LINCOLN PARK PLANNING COMMISSION
CITY HALL – COUNCIL CHAMBERS 1355 SOUTHFIELD ROAD
LINCOLN PARK, MICHIGAN

AGENDA

Site Plan Review

Site Plan Review

SHEET TITLE:
OVERALL SITE PLAN
W/ AERIAL VIEW

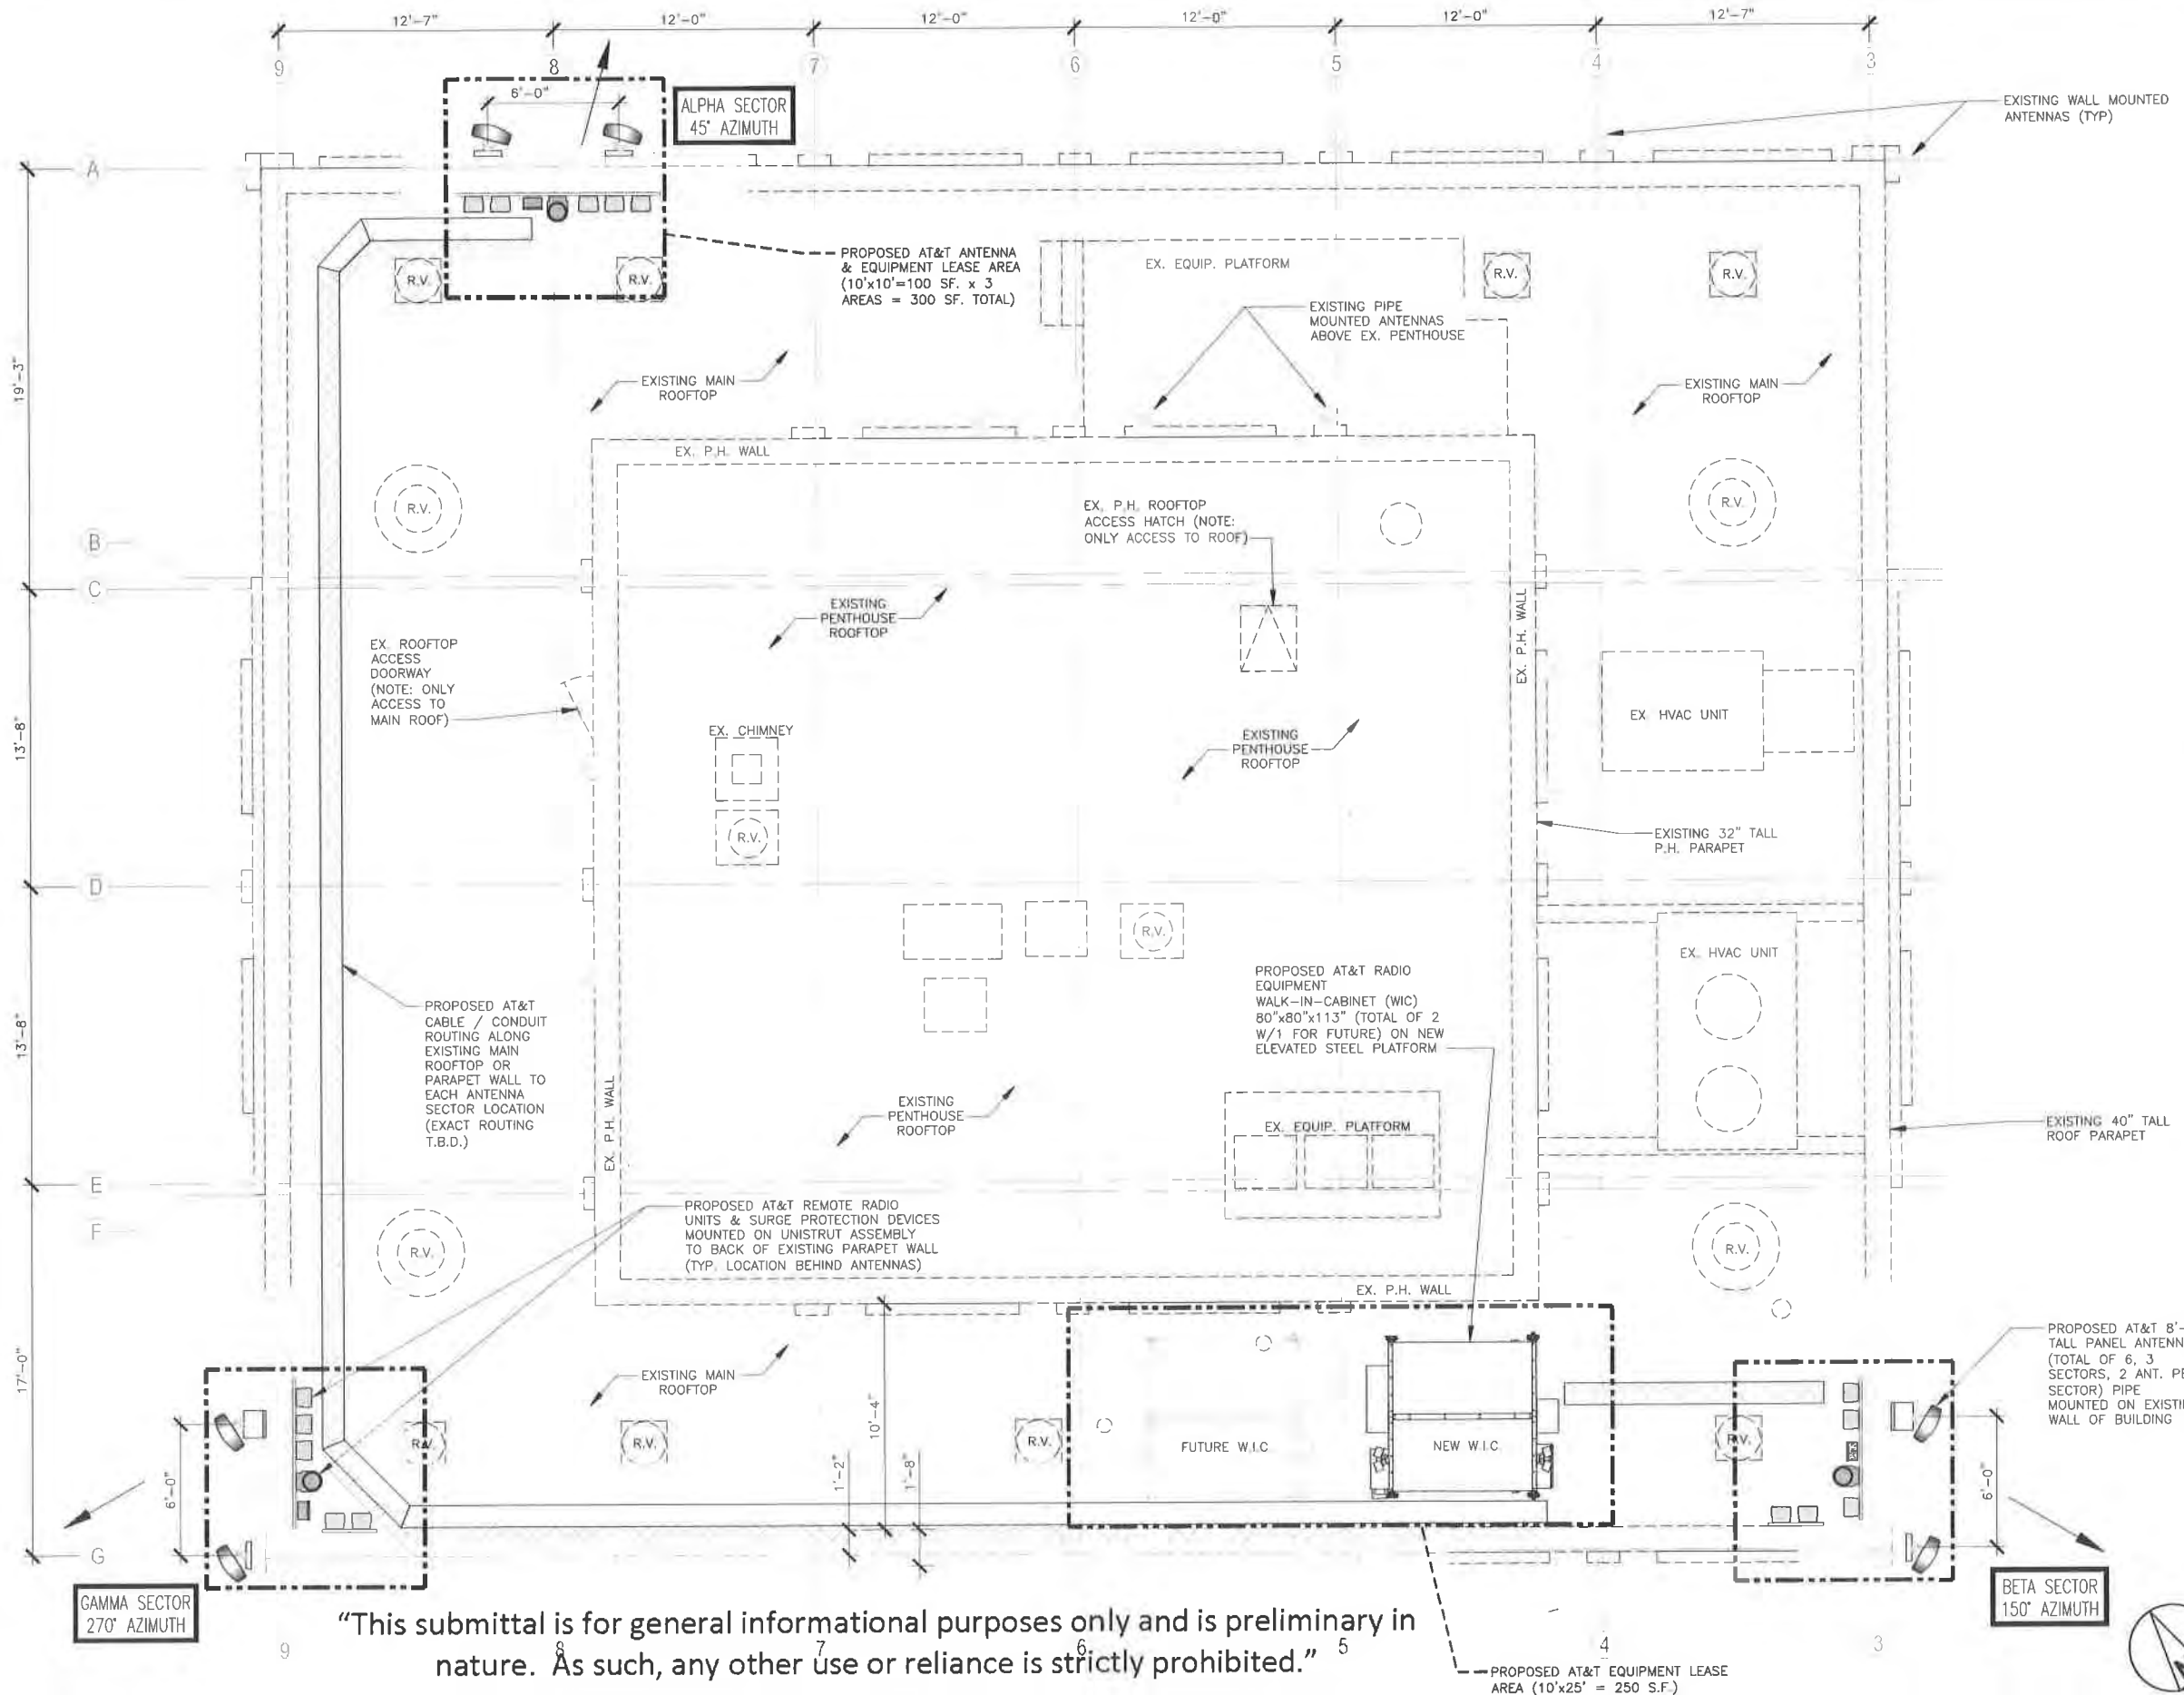
- Applicant shall provide Corrected photo simulated roof diagram and elevations to match the proposed design as presented in the planset.
- Applicant shall provide manufacturing specifications of all AT&T radio equipments.
- Applicant shall confirm that a clear and unobstructed access to the building is obtained and/or obtain an easement if necessary.
- Applicant shall note that all support system of proposed AT&T radio equipments comply with Federal and State codes.
- Compliance with building codes shall be assessed after site plan approval has been granted.
- Applicant shall provide a clear and specific maintenance plan and/or agreement.

PROPOSED SITE PLAN
SCALE 1" = 20'-0"

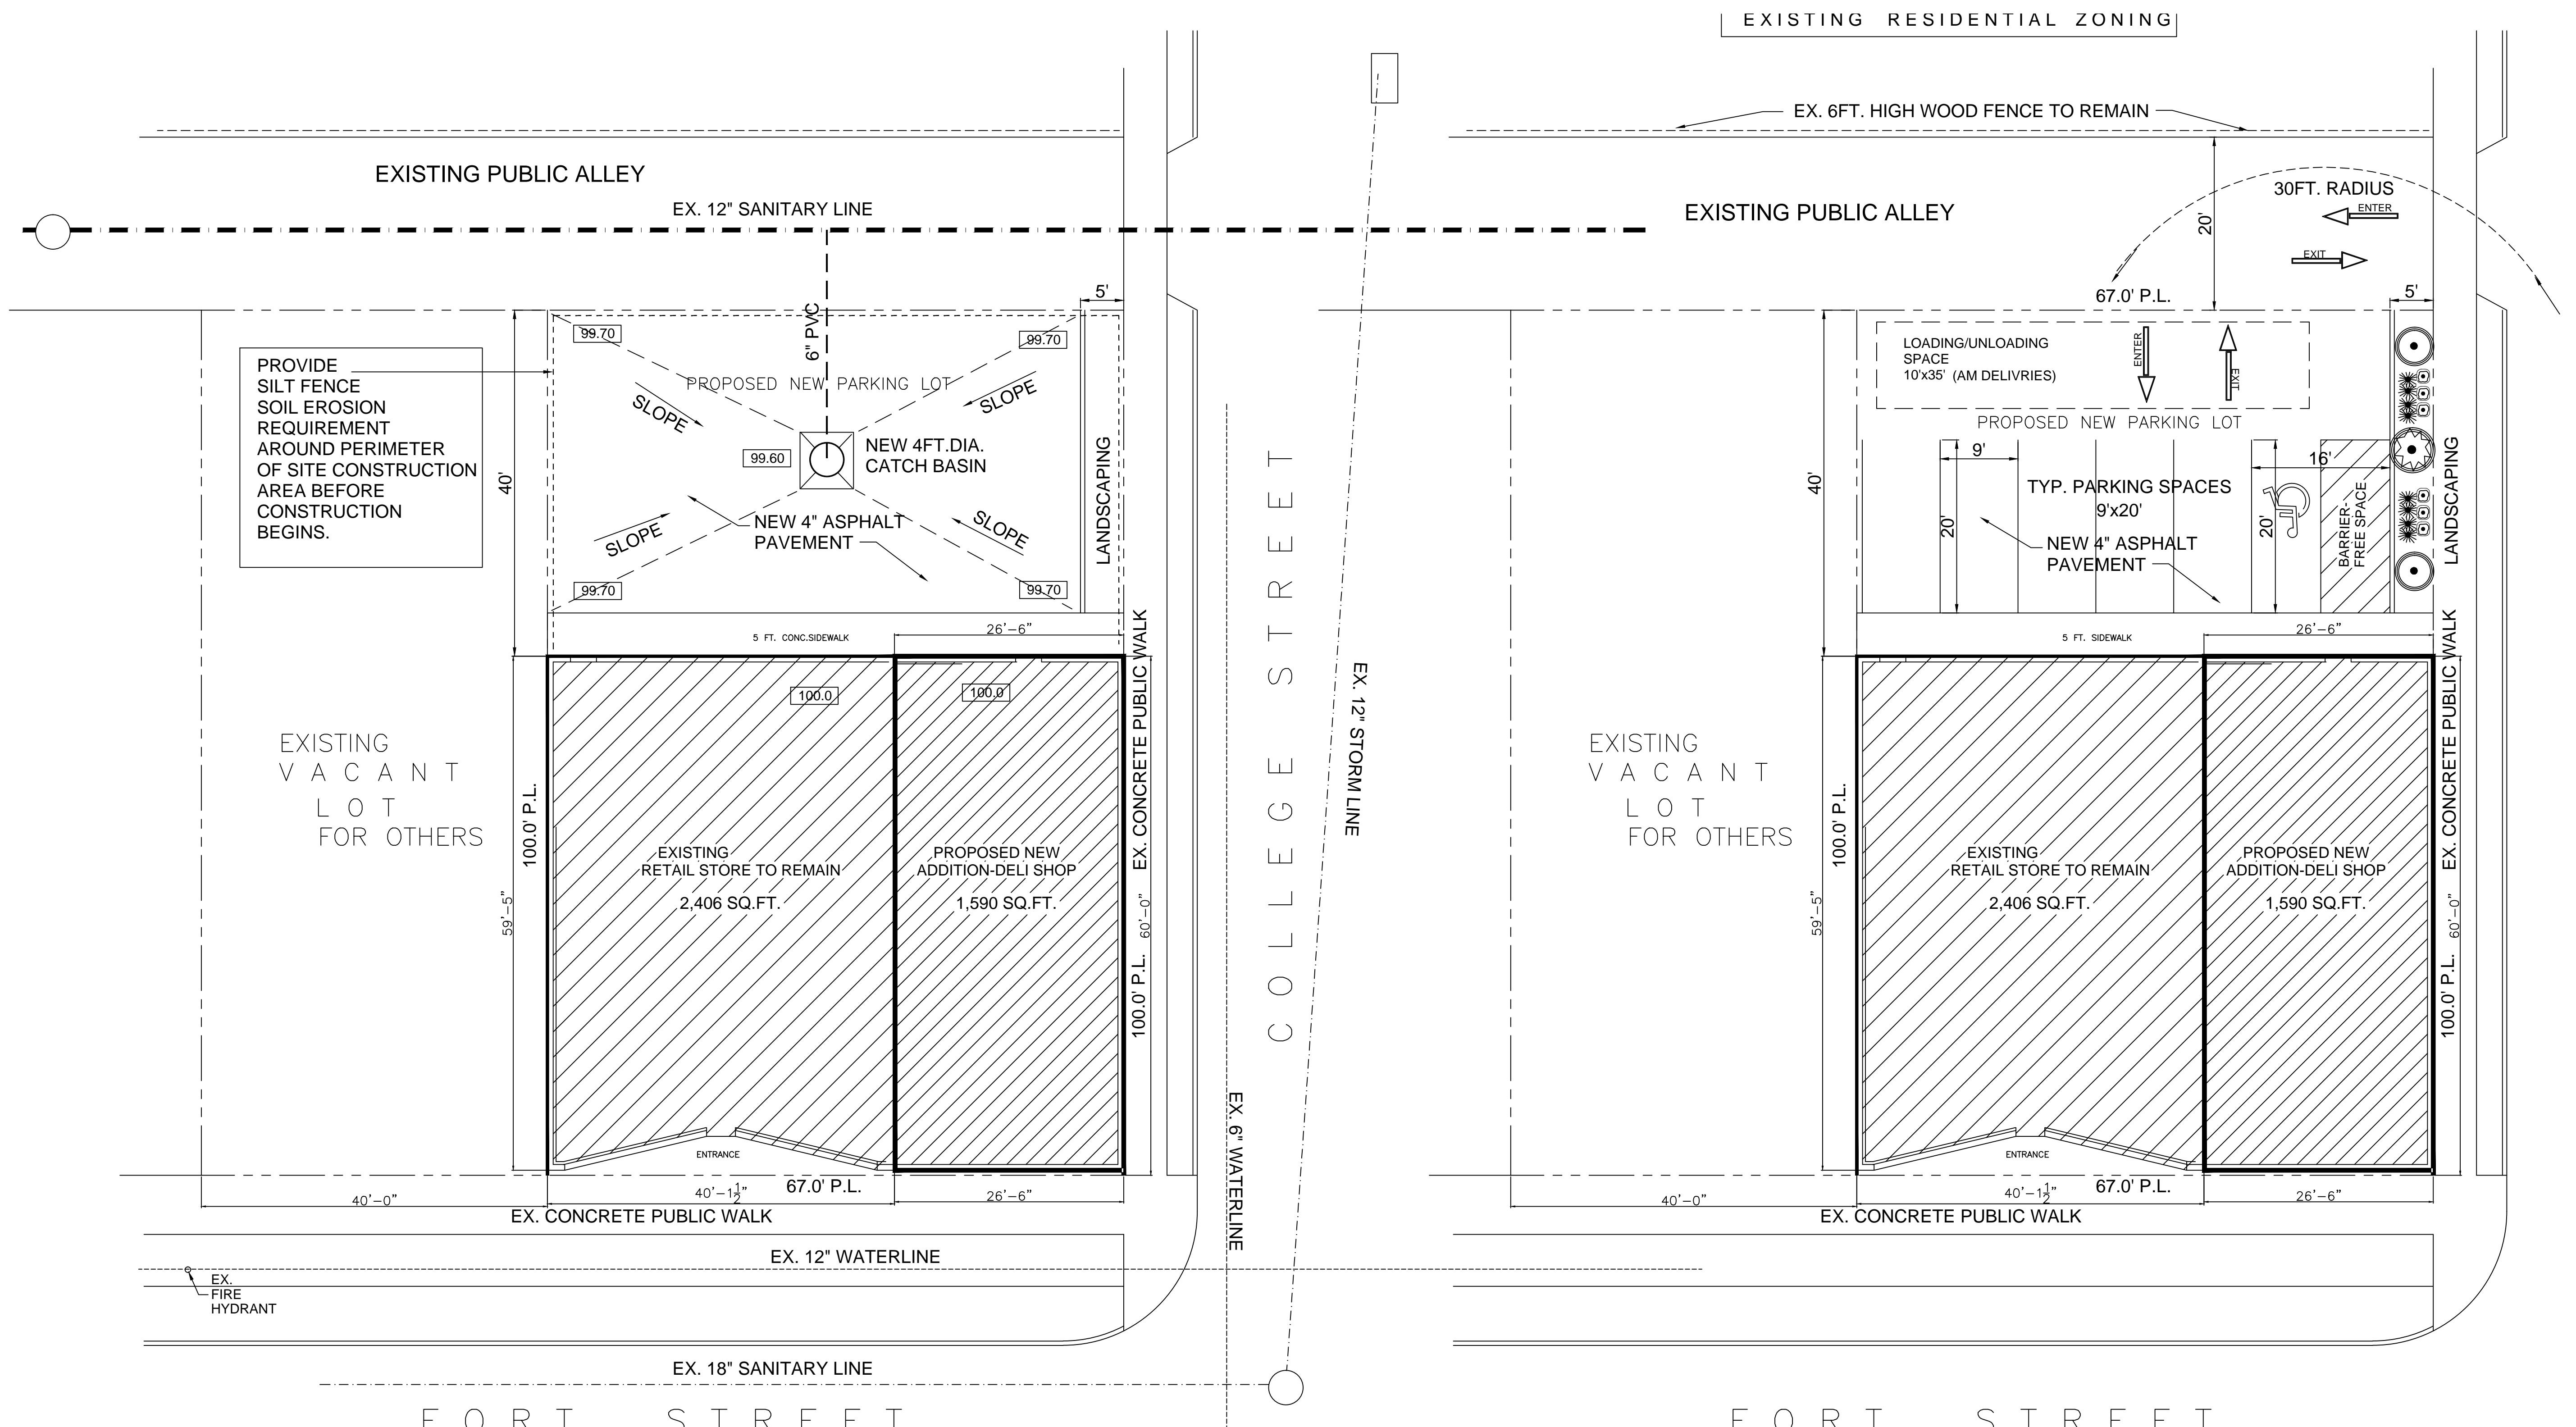
- Site plan scale shall be corrected: it is noted at 1"=20', but measurements indicate that it is 1"=10'
- Planning commission to advise applicant about methods of reducing lot coverage to 50%

- The detailed engineering plans will need to show and have labeled all existing utilities.
- Sheet SP-1 shows a 6" pvc storm line tied into a sanitary sewer. No storm water can be tied into a sanitary sewer system. The catch basin will need to be tied into the storm sewer system.

1. The detailed engineering plans will need to show and have labeled all existing utilities.
2. Sheet SP-1 shows a 6" pvc storm line tied into a sanitary sewer. No storm water can be tied into a sanitary sewer system. The catch basin will need to be tied into the storm sewer system.

- *Detailed engineering plans will need to show and have labeled all existing utilities.*
- *Sheet SP-1 shows a 6" pvc storm line tied into a sanitary sewer. Applicant shall revise drawing in accordance with DPS instruction.*
- *The new addition is recommended to be serviced by new water and sanitary sewer services.*
- *If the existing services are provided for tie-in by the Plumbing Inspector, applicant shall videotape the existing sewer lead to determine its condition prior to building the new addition. If the service lead needs to be replaced, the installation of the new service will need to be inspected by our office.*
